S4.55(2) MODIFICATION APPLICATION

29 Shirley Street and 2-4
Milton Street, Byron Bay

Director	Patrick Hefferan
Associate Director	Melissa Griffin
Consultant	Kerri Mereider
Project Code	P0038351
Report Number	FINAL JUNE 2024

Figure 11 Modified Elevation Plan from Shirley Street (South Building)

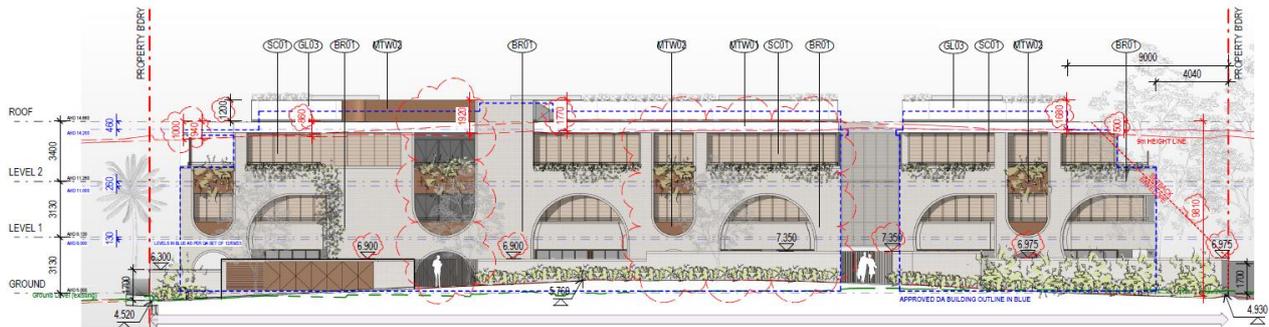
The modified elevation plan of the southern building fronting Shirley Street is illustrated below in **Figure 11** with the inclusion of the approved DA building outline shown in a dashed blue, the floor to floor levels per the approved DA set shown in a dashed red, and the 9m height line shown in a solid red line in accordance with the ground level (existing) in a dashed green line.

As shown below and within the revised architectural scheme, the southern building has been modified to marginally increase its floor to floor heights to achieve a minimum 2.7m ceiling height to living areas and bedrooms. As a result, the total extent of the building has increased resulting in the rooftop balustrading and lift-overrun marginally exceeding the 9m building height line.

Figure 13 Modified Elevation Plan from Eastern Elevation (South Building)

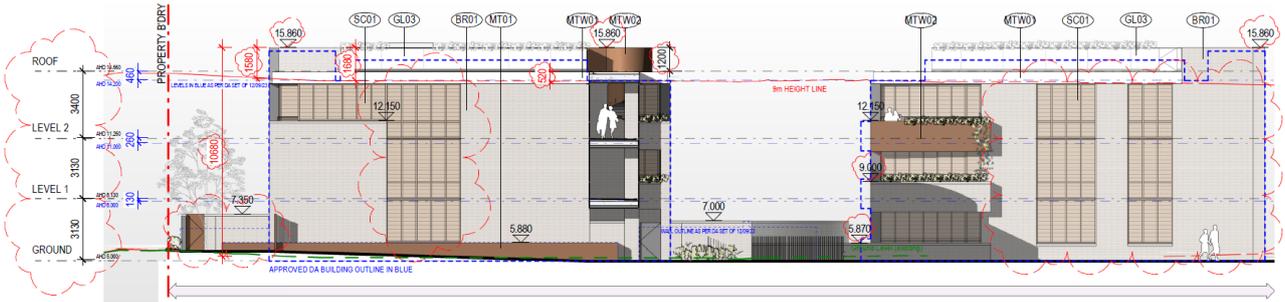
Further to the modified building height, the amendments to the southern building also include the following:

- Fixed privacy screening with a height of 1.73m is incorporated along the terrace area of Unit 201 adjacent to the adjoining lot;
- Fixed louvered privacy screening incorporated along the balcony of Unit 101 adjacent to the adjoining lot;
- A 2m high masonry acoustic wall incorporated along the eastern boundary in accordance with the noise impact assessment report; and
- Amendments to the external façade and materials.

Figure 14 Southern Building - Ground Floor Plan

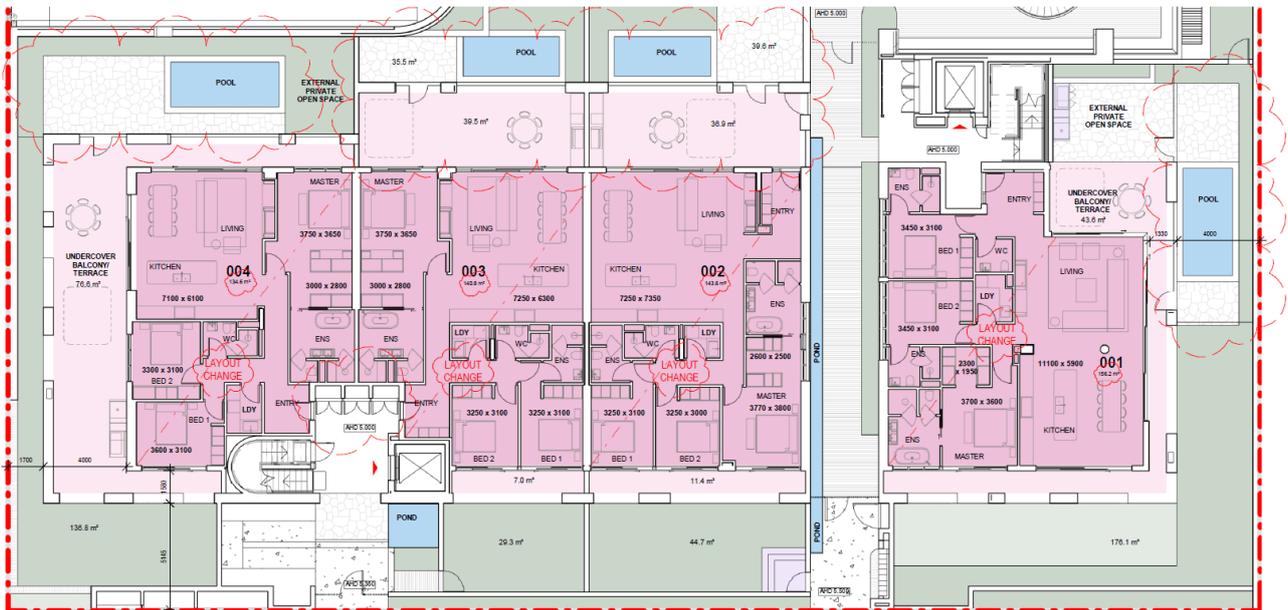
The modified ground floor plan as shown below in **Figure 14** notes various minor amendments to the internal reconfigurations of dwelling 001 – 004. The floor plans of these dwellings have been revised as part of marketing and the design development process; however, the number of bedrooms has been retained from the original approval.

Figure 15 Modified Elevation Plan from Northern Boundary (North Building)

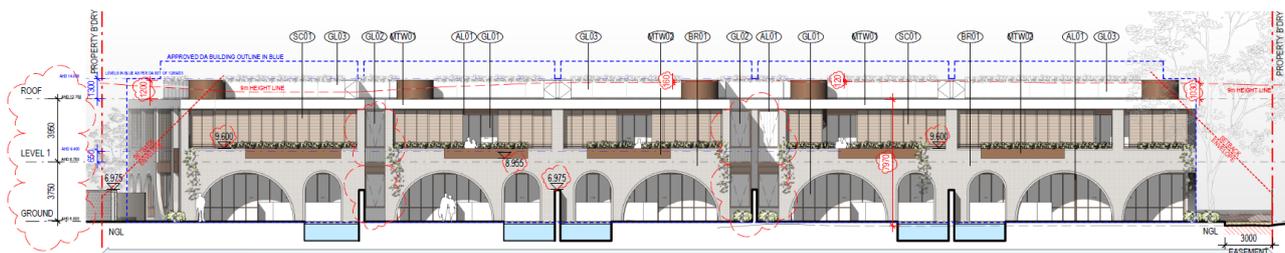
The modified elevation plan of the northern building from the northern perspective are shown in **Figure 15** and **Figure 16** below which incorporates an overall reduction in total building height. This reduction has been achieved by reducing the floor to floor heights. As a result, the majority of the building is now set at 9m or below, with the exception of a minor portion of balustrading and lift-overrun which marginally exceeds the 9m height line.
